Mercedes-Benz

Campaign No. 2020100010, October 2020

SUBJECT: **Model GLB-Class vehicles (247 platform)**  
**Model Year 2020**  
**Check Mounting Window Airbag**

**Figure 1**

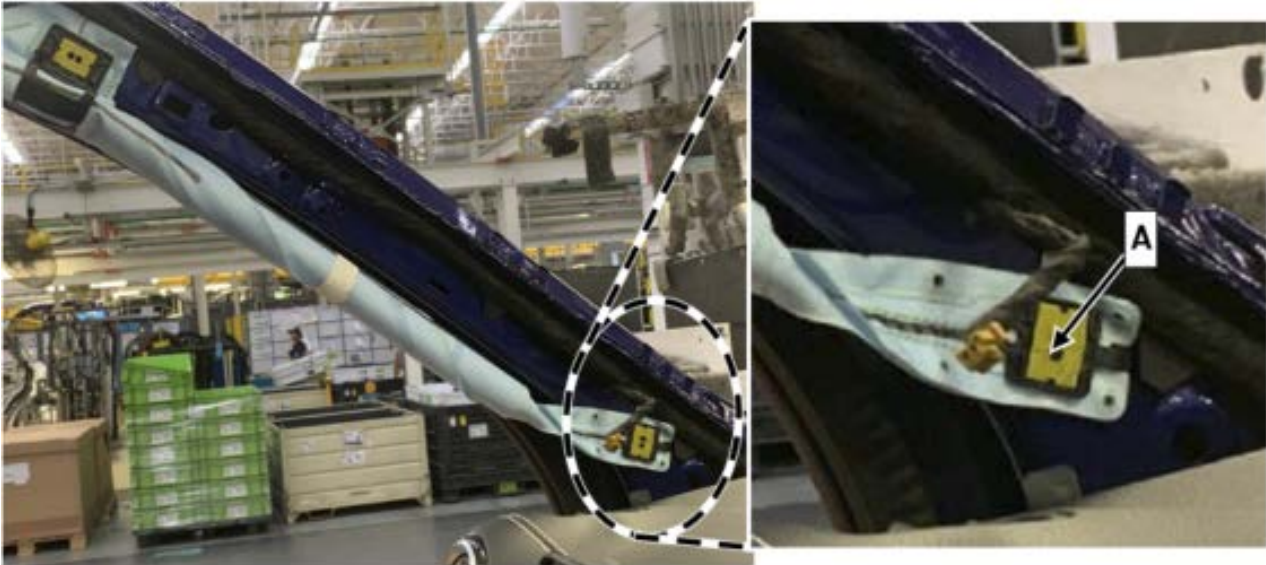
2. Press on clip **(A, Figure 1)**.
3. Grasp fabric tape and pull on it.
4. Press on clip **(A, Figure 1)** again.

**i** The clip **(A, Figure 1)** must be attached correctly.
5. Assemble in reverse order.
